SILVERADO RANCH FILING NO. 2

Construction Drawings El Paso County, Colorado

TITLE SHEET

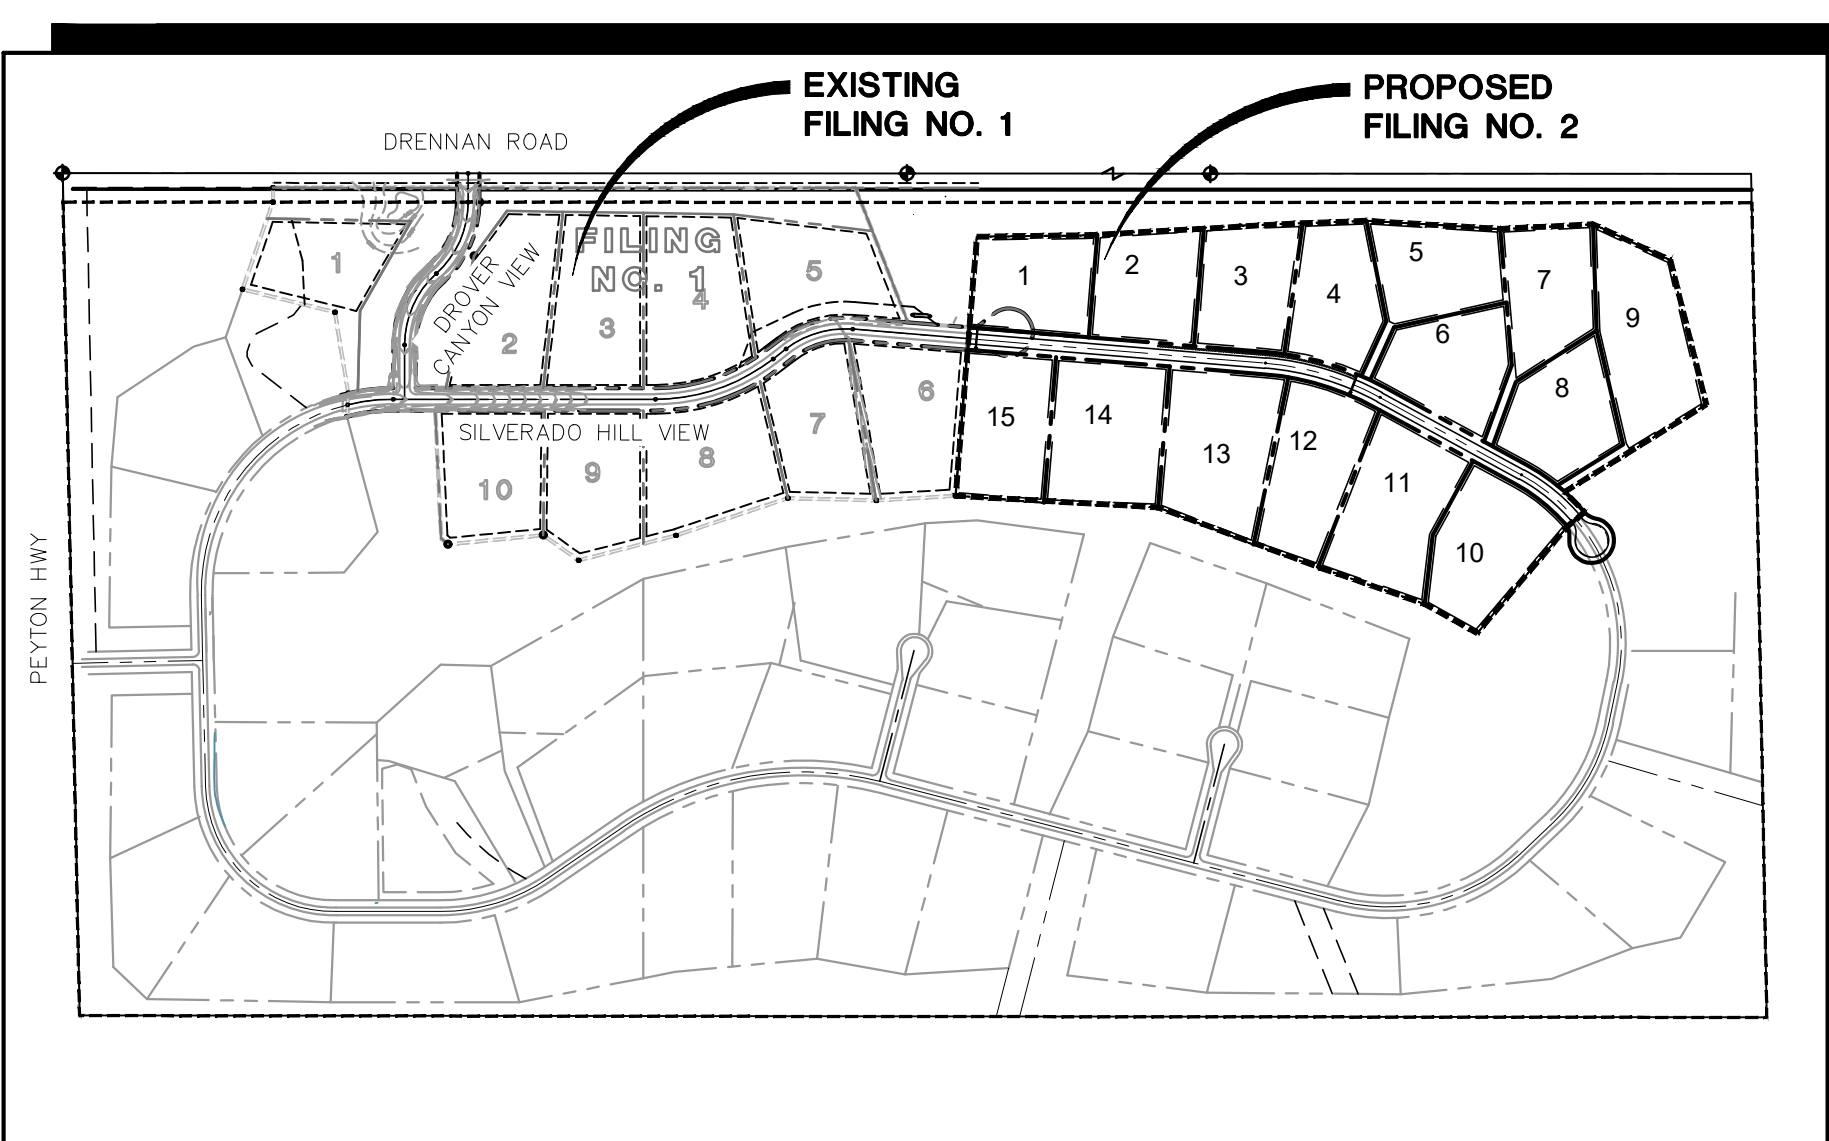
Please update the CD to match the FDR whenever changes are made to the FDR. This comment stays unresolved until no changes being made on the drainage report.
